UNITED STATES PATENT AND TRADEMARK OFFICE

APPLICATION NO.	FILING DATE	FIRST NAMED INVENTOR	ATTORNEY DOCKET NO.	CONFIRMATION NO.
10/588,006	09/20/2006	Quentin Baillia-Prel	0579-1128	1367
<div>466 7590 03/18/2011</div> <div>YOUNG & THOMPSON 209 Madison Street Suite 500 Alexandria, VA 22314</div>				
<div>EXAMINER</div> <div>LUGO, CARLOS</div>				
<div>ART UNIT PAPER NUMBER</div> <div>3673</div>				
<div>NOTIFICATION DATE DELIVERY MODE</div> <div>03/18/2011 ELECTRONIC</div>

Office Action Summary**Application No.**

DETAILED ACTION

attachment #1

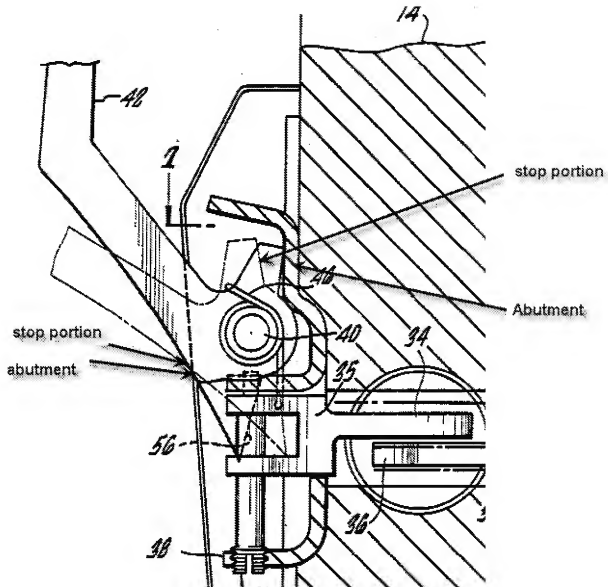
The fixed part has an abutment configured to cooperate with a stop on the bar (attachment #1) to delimit a range of pivot motion.
